SUNDRY NOTICES AND REPORTS ON WELLS
Do not use this form for proposals to drill or to re-enter an abandoned well. Use form 3160-3 (APD) for such proposals.

8. Well Name and No.
REESE MESA 8S

HILCORP ENERGY COMPANY
REESE MESA 8S
MIT SUNDRY

Re: Mechanical Integrity Test

REESE MESA 8S - CURRENT WELLBORE SCHEMATIC

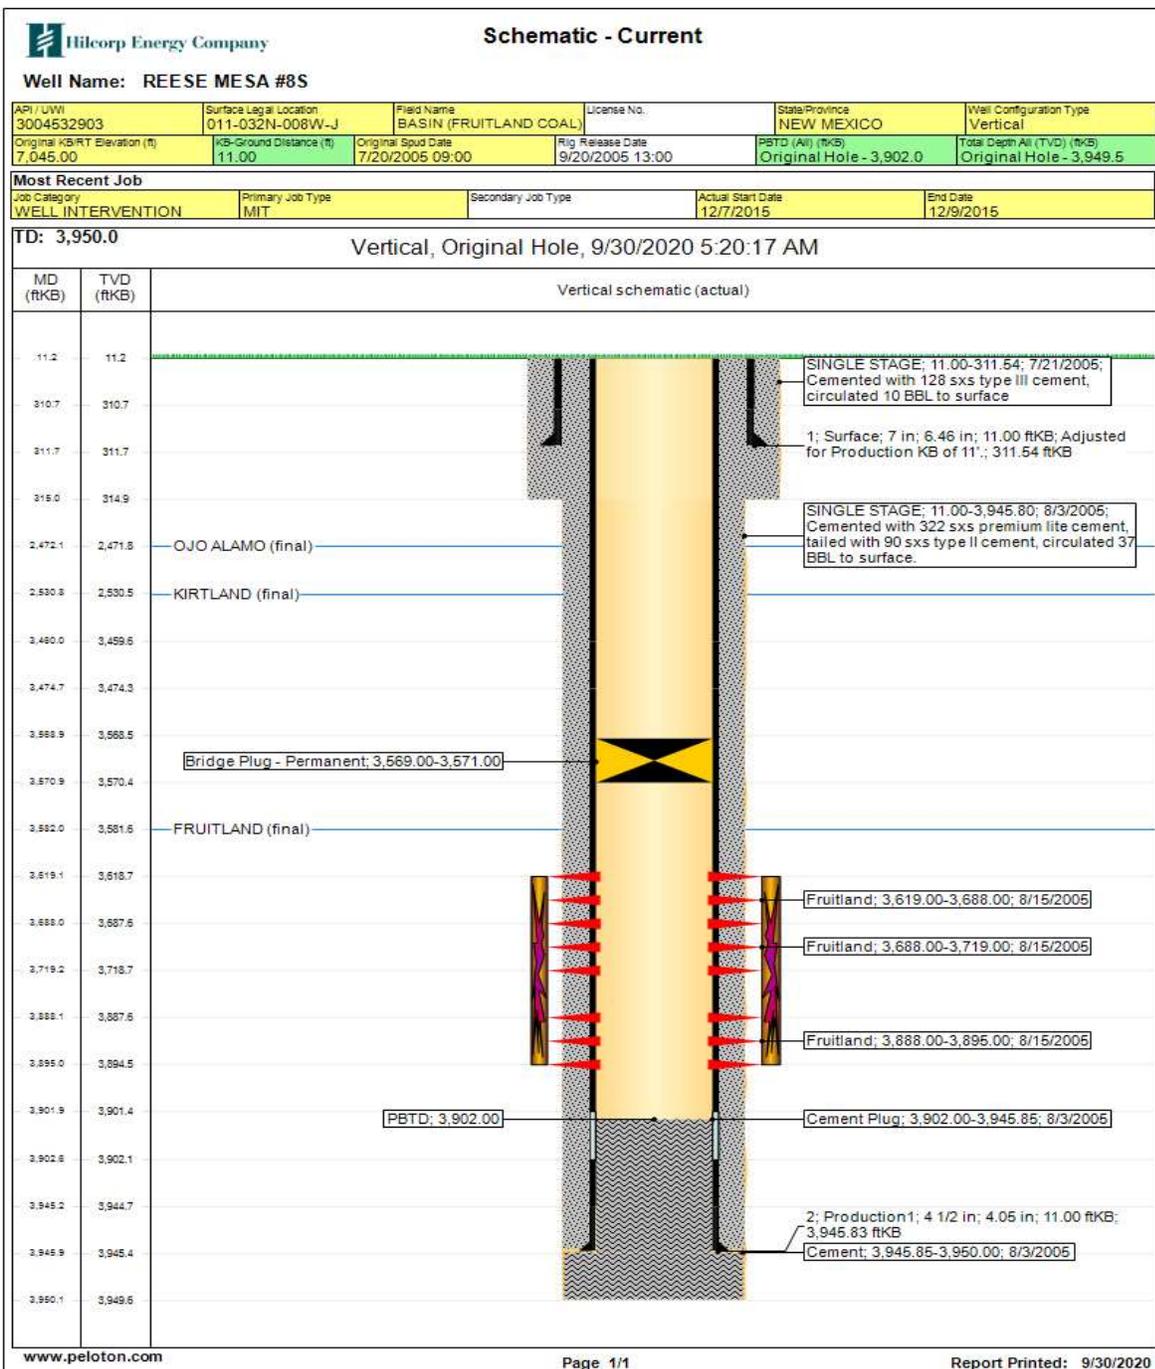
1. In order to evaluate a request for further extension of TA status, please submit justification of future economic potential for the well with a TA extension request if MIT is successful.

OCD Reviewer	Condition
ahvermersch	Correction to above COA=BLM has approved this sundry
mkuehling	BLM has not approved - test needs to start at zero and end at zero - bradenhead test is required prior to MIT - both tests can be witnessed through facetime as long as there is good cell service.
